Addendum #	2	Date Issued	10-25-2024
Project Name Job #	DSU Woods Hall Improvements - Phase 2		20233600
Bid Date Time	November 20, 2024		2 pm MDT

THIS ADDENDUM AMENDS AND BECOMES PART OF THE CONTRACT DOCUMENTS FOR EAPC PROJECT 20233600 DATED 1-16-2024. EACH BIDDER SHALL ACKNOWLEDGE RECEIPT OF THIS ADDENDUM BY MARKING THE ADDENDUM NUMBER AND DATE ON THE BID FORM.

M4.1

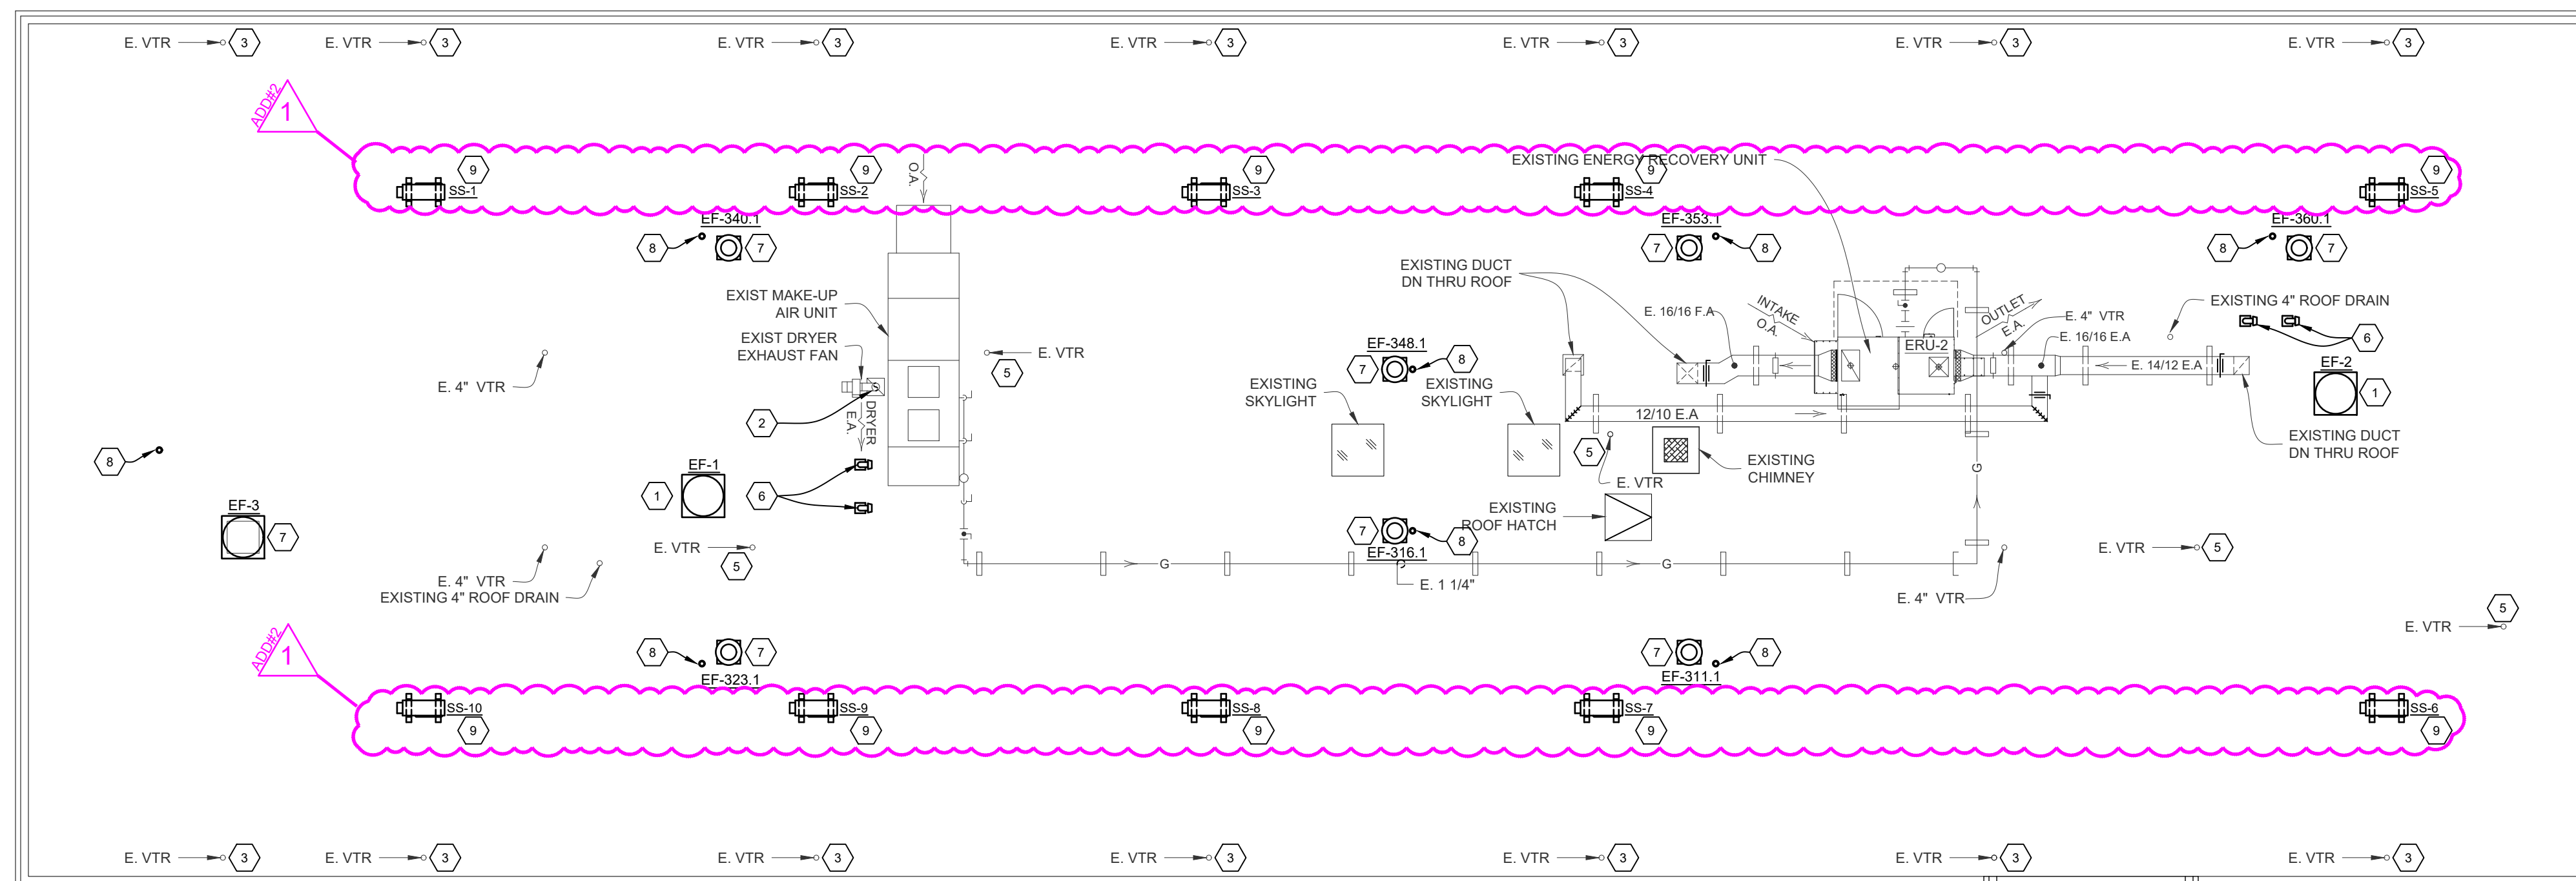
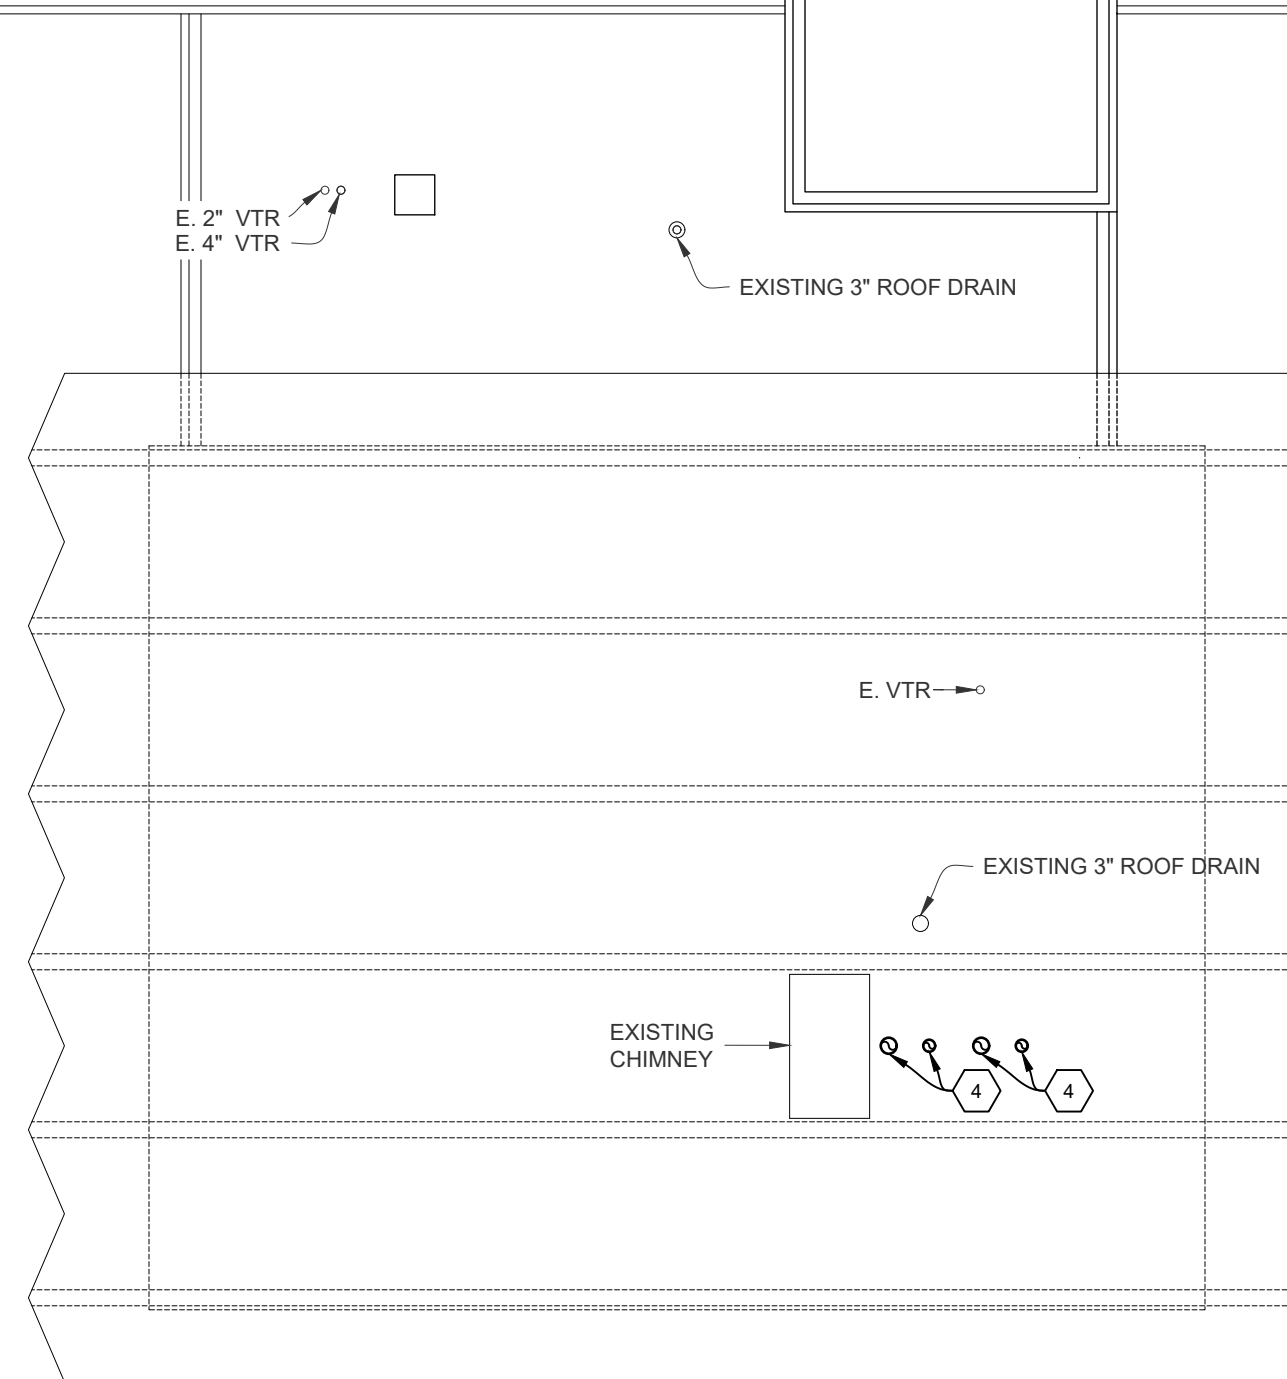
- a. Added Multi-Mini Split System Outdoor units on the roof.
- b. Updated and added keynotes.

1 E1.0 BASEMENT EXISTING CONDITIONS
SCALE: 1/8" = 1'-0"

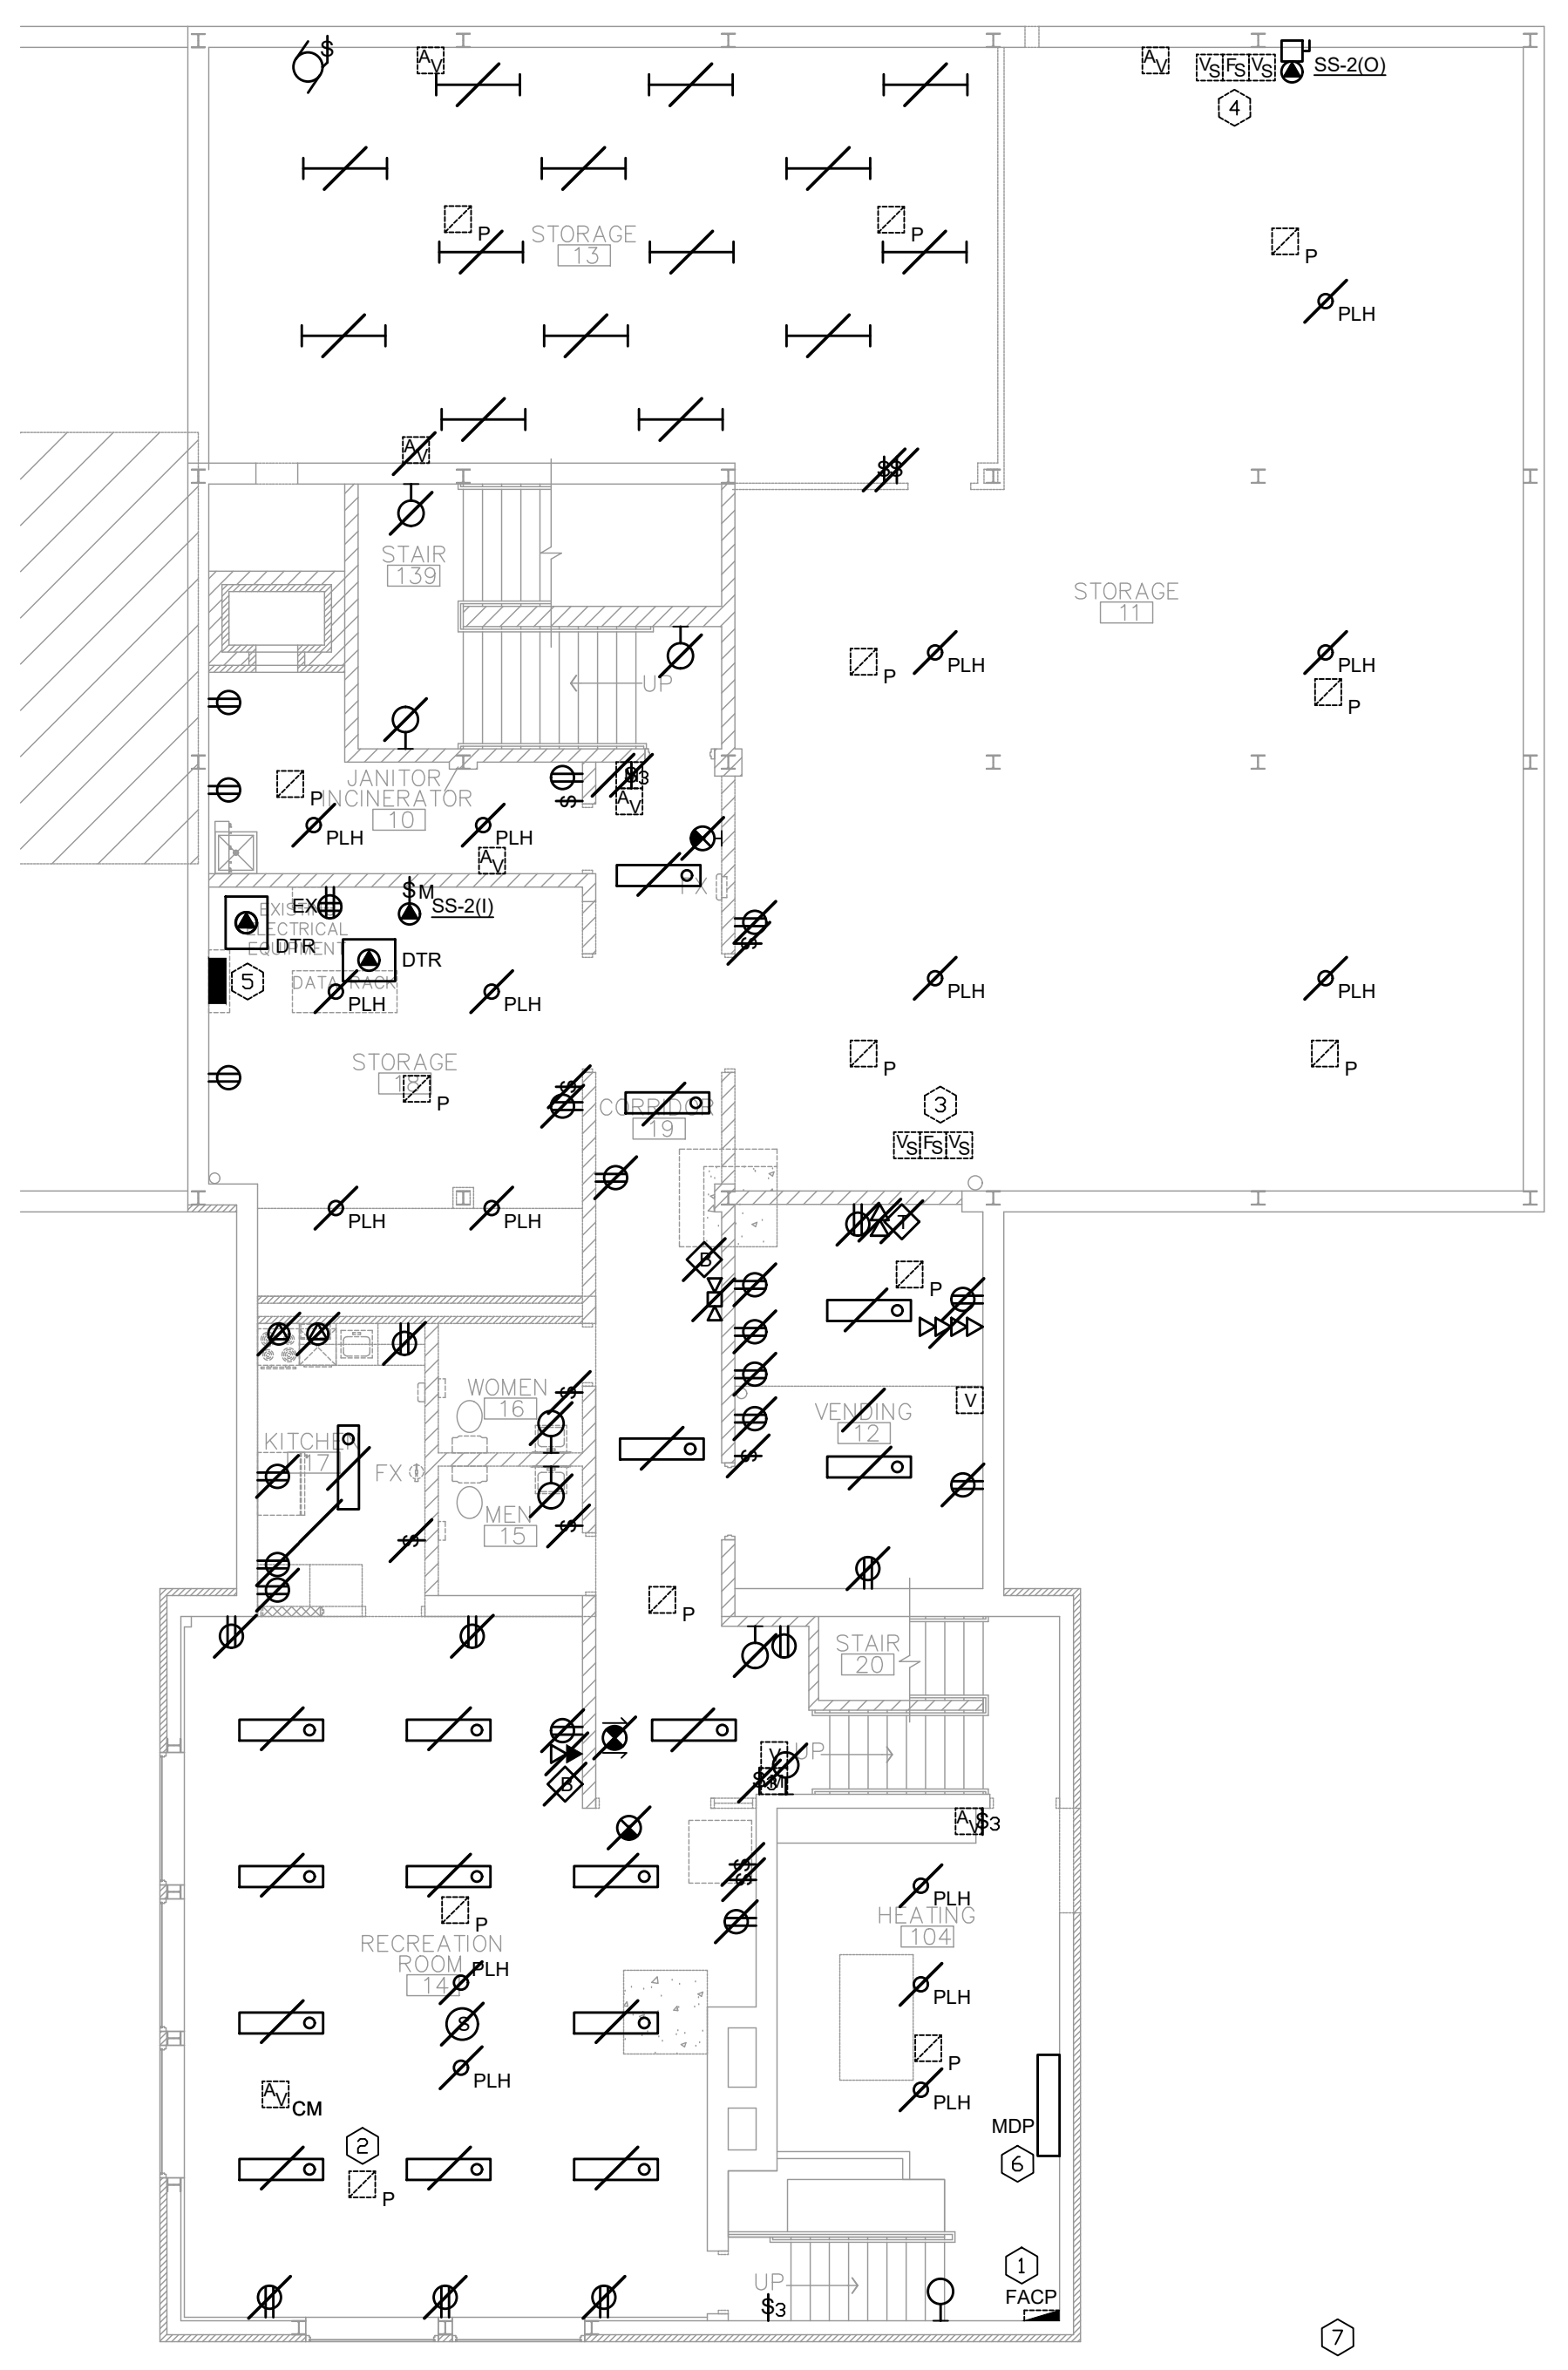
Replace sheet with revised sheet E1.0, attached.

THIRD FLOOR AIR CONDITIONING PLAN
SCALE: 1/8" = 1'-0"

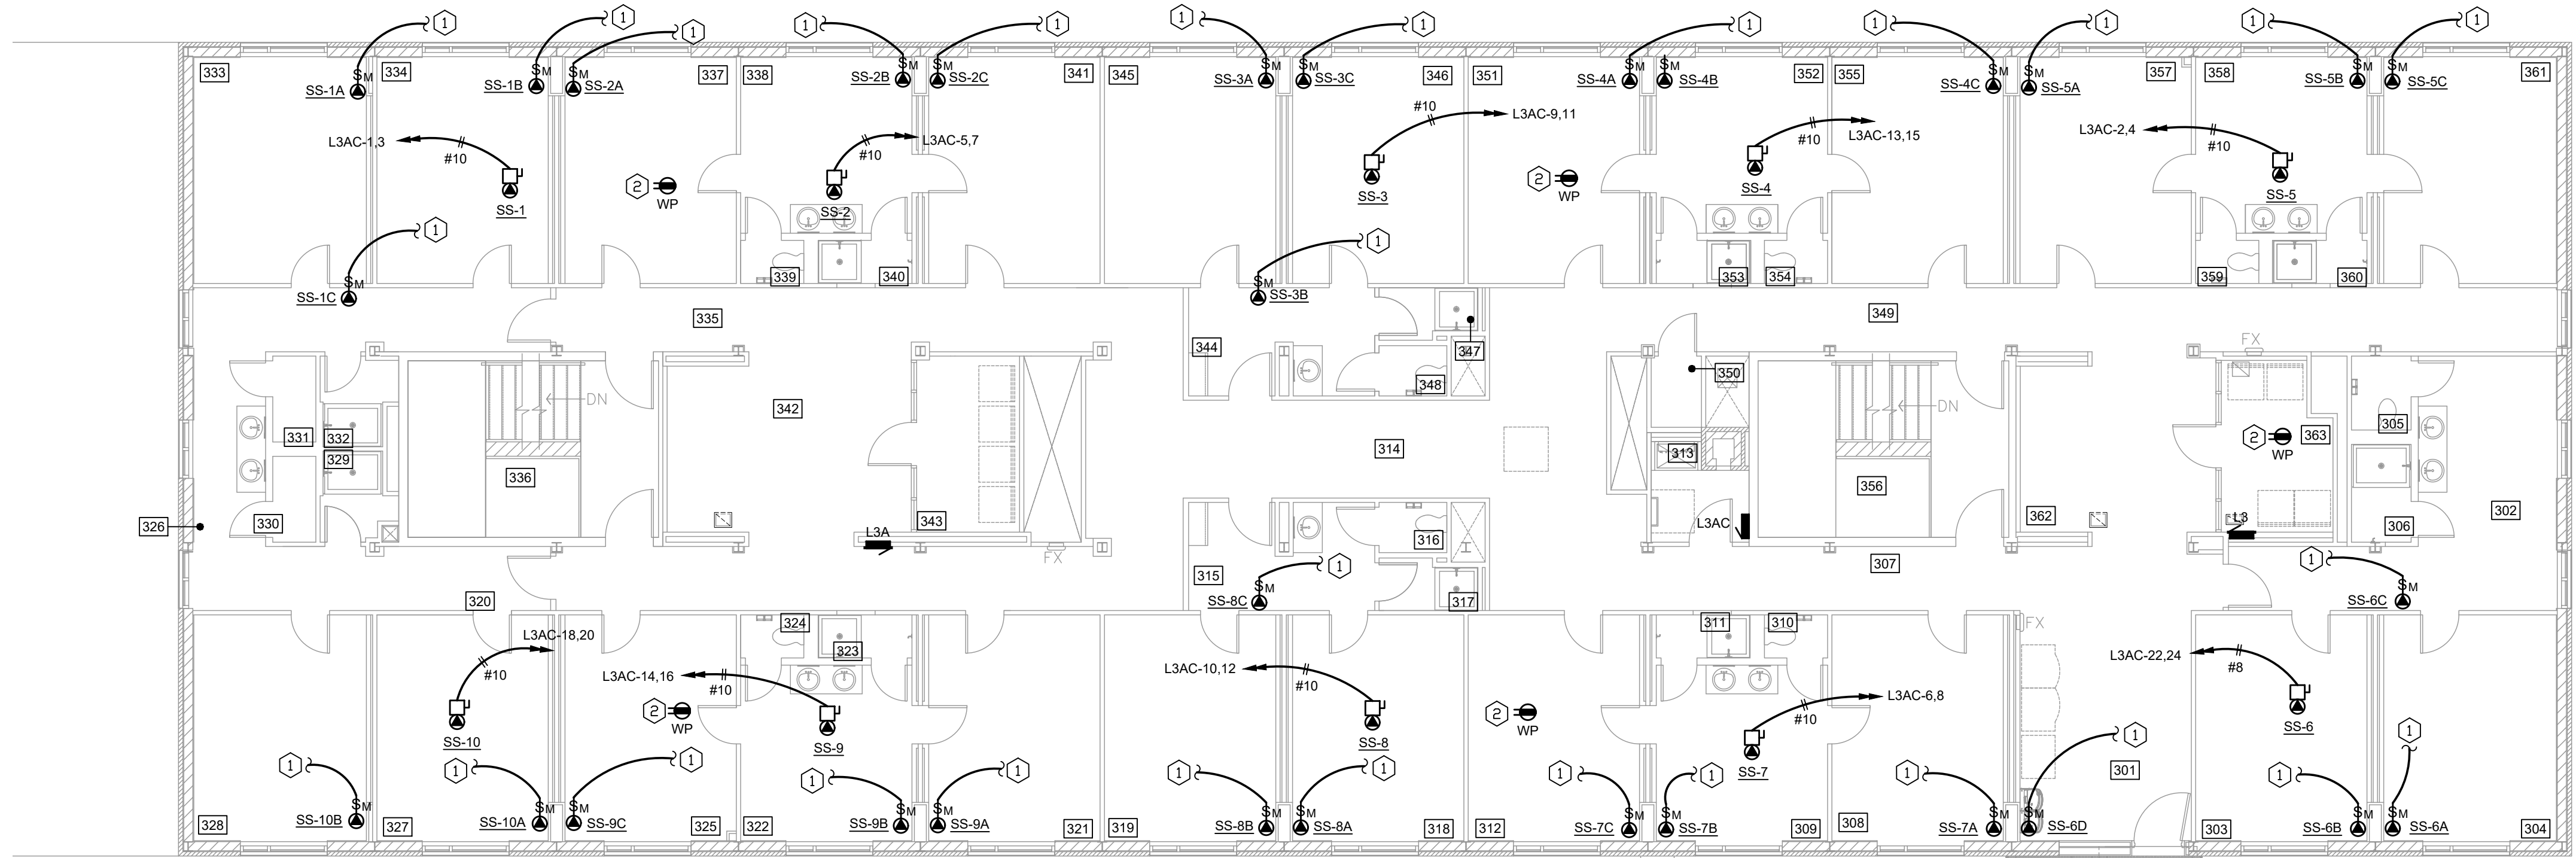
Replace sheet with revised sheet E3.0, attached.
